Project	IEEE 802.16 Broadband Wireless Access Working Group < http://ieee802.org/16 >	
Title	Comments on channel modeling	
Date Submitted	2007-05-09	
Source(s)	Dean Kitchener, Kelvin Au, Robert Novak, Mo-Han Fong, Sophie Vrzic, Jun Yuan, Peiying Zhu, Wen Tong, Jianglei Ma	Voice: +44-1279-403118 Fax: +44-1279-402100 mail to: deank@nortel.com mhfong@nortel.com
	Nortel	
Re:	This is a response to a call for contributions http://www.ieee802.org/16/tgm/docs/80216m-07_014r1.pdf	
Abstract	Recommendations for user speed distribution and wideband channels (>5MHz)	
Purpose	For consideration when specifying channel models for the evaluation methodology	
Notice	This document has been prepared to assist IEEE 802.16. It is offered as a basis for discussion and is not binding on the contributing individual(s) or organization(s). The material in this document is subject to change in form and content after further study. The contributor(s) reserve(s) the right to add, amend or withdraw material contained herein.

Comments on channel modelling

Dean Kitchener, Kelvin Au, Robert Novak, Mo-Han Fong, Sophie Vrzic, Jun Yuan, Peiying Zhu, Wen Tong, Jianglei Ma
Nortel

Figure 1 – HSDPA user speed distribution

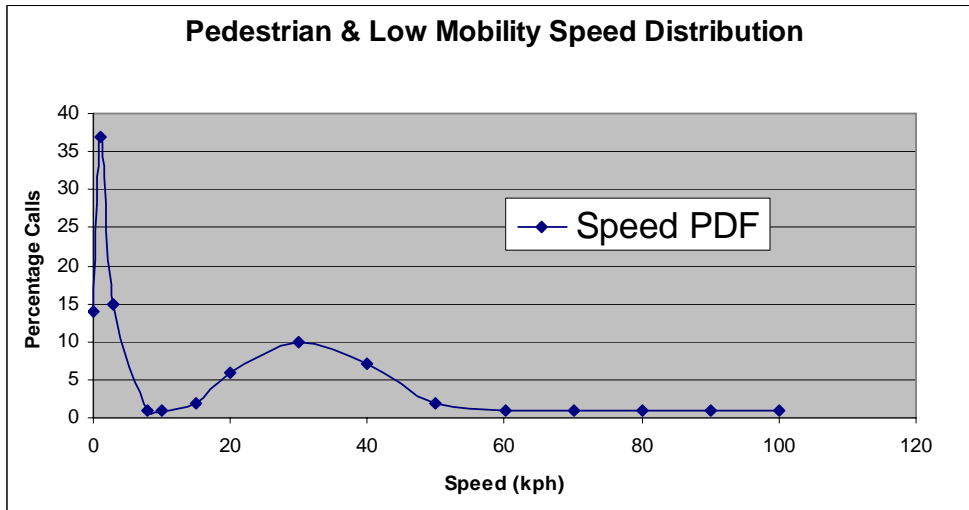
The key thing to note for all of the above recommendations is that there are no stationary users. For IMT-Advanced, delivering high data rate multimedia services, it is expected that many users will be stationary, since the user will need to look at the information being received. This has been taken into account in the specification of parameters for HSDPA simulations where the user speed distribution given in Figure 1 is used [2] (see also Table 5). In this case it can be seen that 14% of users are stationary and 51% of users have speeds ≤ 1 kph. It is recommended that this distribution also be used for macrocellular system simulations for IEEE 802.16m. For the hotspot layer this distribution will be different again, where in this case all users are likely to be walking or stationary (all ≤ 3 kph).

For system simulations, the user speed will be completely independent of the actual channel characteristic (TDL model) at each location. It is therefore recommended that the TDL model assignment probability be decoupled from the user speed probability. It is also recommended that for stationary users the Doppler spectrum for the taps should be modified to that used in [3] for fixed links.

The HSDPA speed distribution contains a large number of user speeds. To simplify the system simulation these can be reduced to a smaller set, but with a similar probability distribution:-

Figure 2 – Magnitude of the spaced-frequency correlation function for ITU Ped B

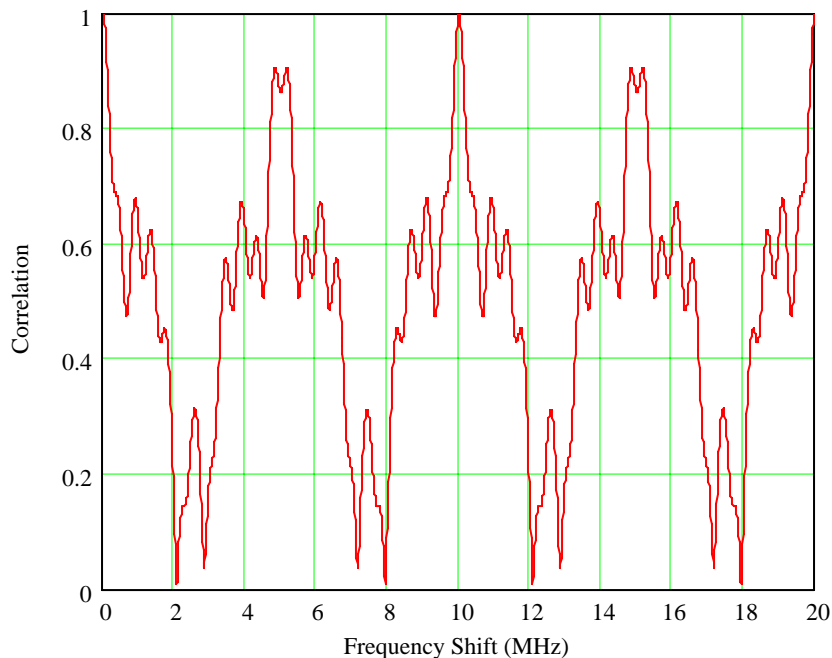
The function is shown plotted for the ITU Ped B channel in figure 2, for bandwidths up to 20MHz. It can be seen that it has a period of 10MHz, but even at 5MHz the correlation is high. This clearly shows the need for improved models for bandwidths greater than 5MHz.

It is recommended that the modified ITU models be used for wideband channels (i.e. for bandwidths greater than 5MHz and up to 20MHz). It is recommended that the modified models with $N=2$ be used, without the symmetry constraint.

Figure 3 – Spaced-frequency correlation function for ITU Ped B with the powers of taps 5 and 6 set to zero

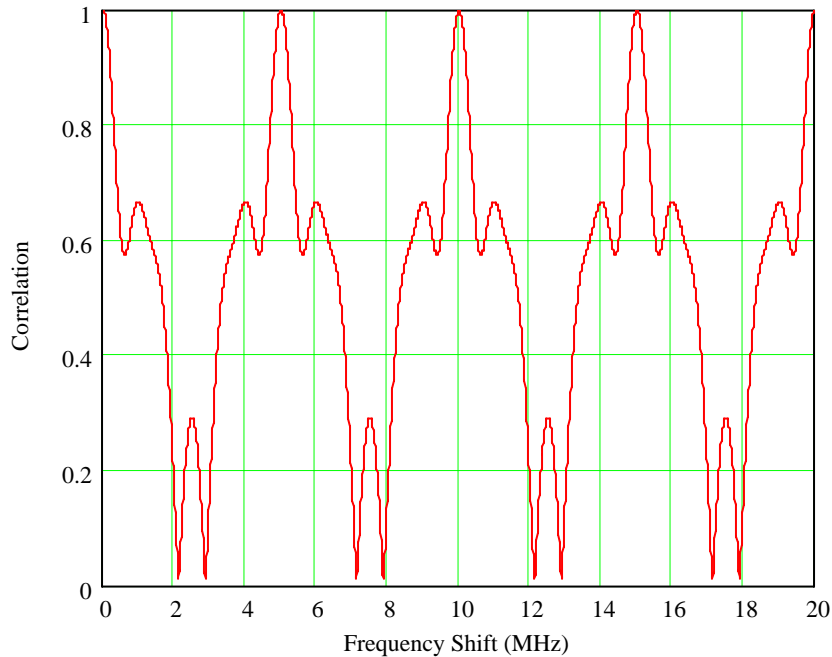
We also note that if the tap powers for taps 5 and 6 (longest delayed components) are set to zero we would expect a period of 5MHz, since taps 2-4 all have integer values for n at 5MHz. This is shown to be true in figure 3.

Figure 4 – Space-frequency correlation function for modified ITU Ped B TDL model

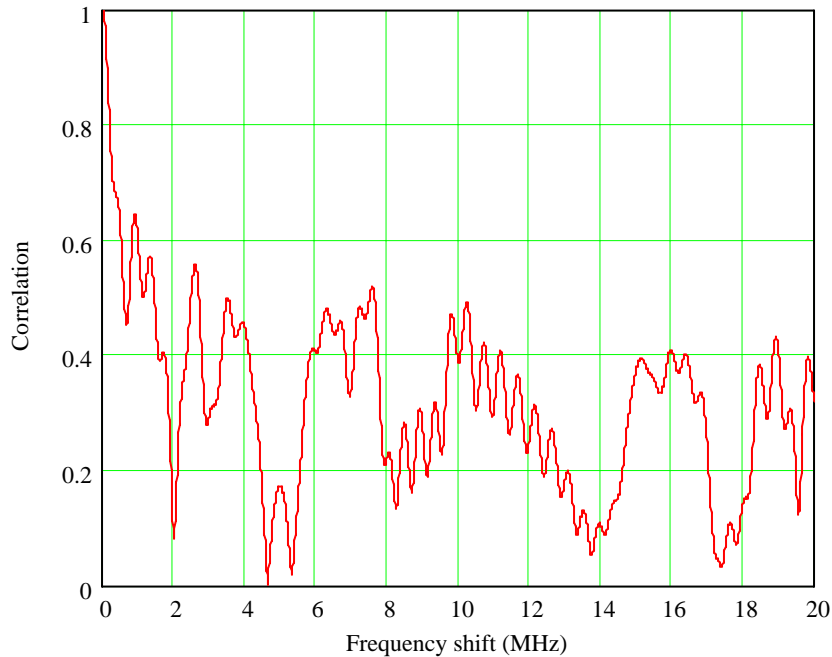
As an example, the spaced-frequency correlation function for the modified ITU Ped B model is shown in figure 4, where N=2 and the symmetry constraint is imposed. It can be seen that this is no longer periodic, and the correlation generally decreases with increasing frequency offset. Clearly, this is a good result even with the symmetry constraint imposed.
